<i>Recall Bulletin</i>	<i>RCL-07-001</i>
	<i>DNA</i>

Subject: Fuel Pump - Fuel Sending Unit Wiring Cables

Models: ST3 - ST3ABS MY 2006

PICTURE 1

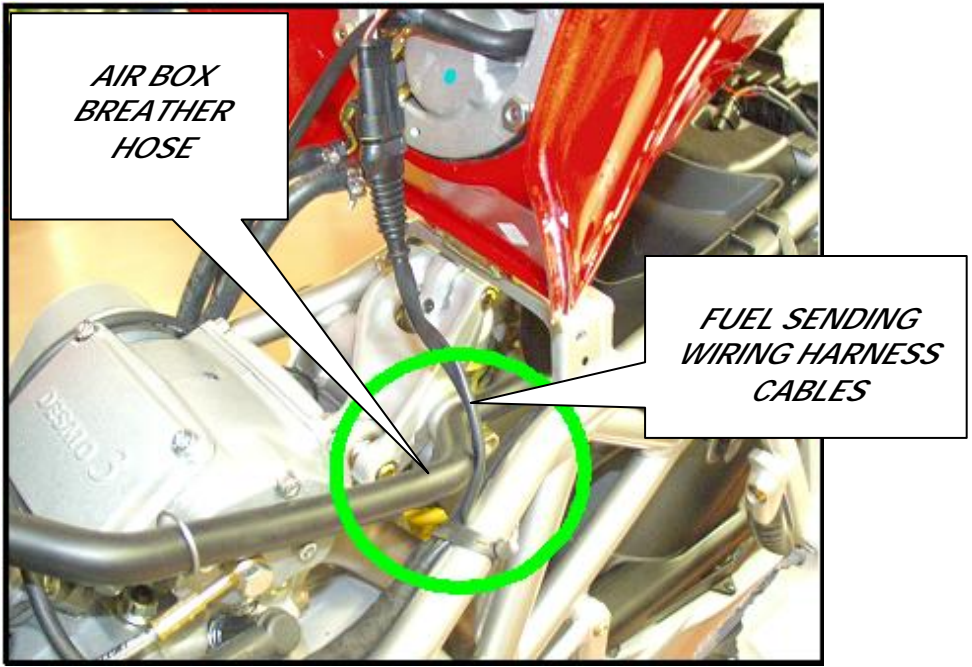
Lift the fuel tank and check that fuel pump cable is routed outside of the air box breather hose as shown below.

Picture (2) below shows *incorrect* cable routing that shall be rectified and set as shown in picture (1) above. It is necessary to reposition it because the cable could touch the vertical cylinder exhaust pipe.

Lift the fuel tank and check that the fuel sending unit wiring cables are routed outside the air box breather hose as illustrated in the instructions attachment.
